<<May 1, 2017>>

Towards that goal, we will be transitioning the standard default offerings for the T14000 and T24650 framing systems.

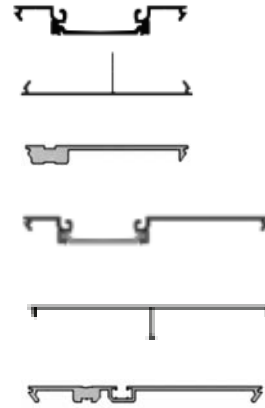
The current defaults are:

- T14000 Vertical Int. - T14445 pocket closure (slotted)
- T24650 Vertical Int. - T14642 pocket closure

The new defaults will be:

- T14000 Vertical Int. - A244040 pocket closure (strut)
- T14000 Head and Sill - P4543A PVC filler
- T14000 Anchor Plates (6") at Head and Jambs - P1130
- T24650 Vertical Int. - A246040 pocket closure (strut)
- T24650 Head and Jambs - P4554 PVC filler
- T24650 Anchor Plates (6") at Head and Jambs - P2460

Retired part:

- T24650 deep pocket closure - T14632
